TRUCK, HEAVY, MC3 – MACK – ALL TYPES

IN-CABIN NOISE REDUCTION AIRCONDITIONER RESISTOR FIT

MODIFICATION INSTRUCTION

3. **Authority.** Engineering Change Orders (ECO) No OVR002/04 – Mack Noise Reduction Resistor Fit is the authority to carry out this modification.

Figure 1 – Bolt Removal

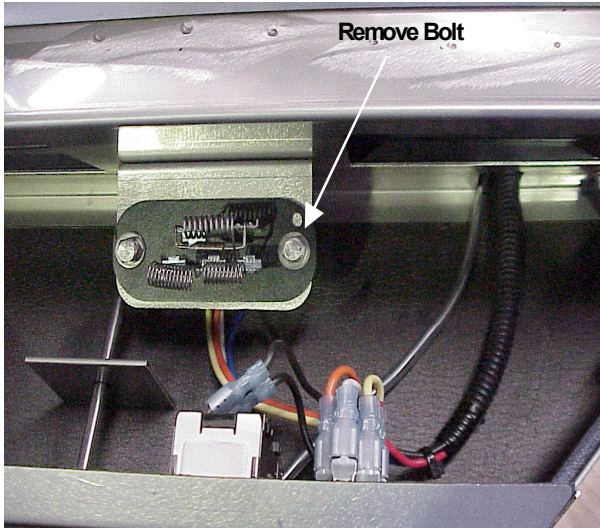
- a. Remove the fibreglass evaporator cover (when airconditioner fitted in vehicle) to expose wiring.
- b. Remove the bolt as indicated in Figure 1.
- c. Locate the resistor pack over the bolt hole and refit the bolt (Figure 2).

Figure 3 – Fitting of Resistor Wires

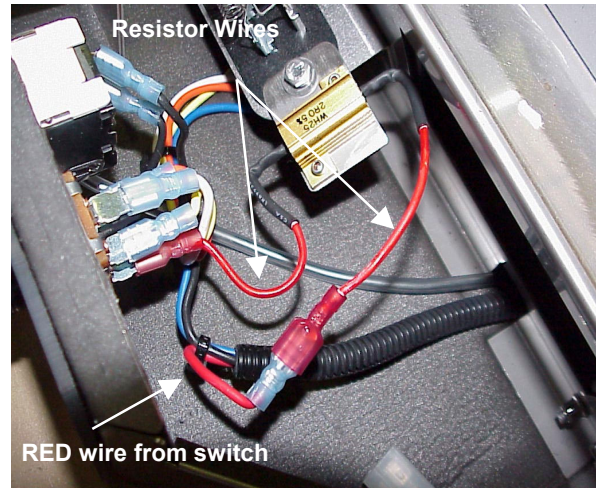
- d. Disconnect the **RED** wire from the back of the fan switch and plug into the male spade end of the resistor wire. Plug the other female terminal end of the resistor onto the fan switch terminal (Figure 3).
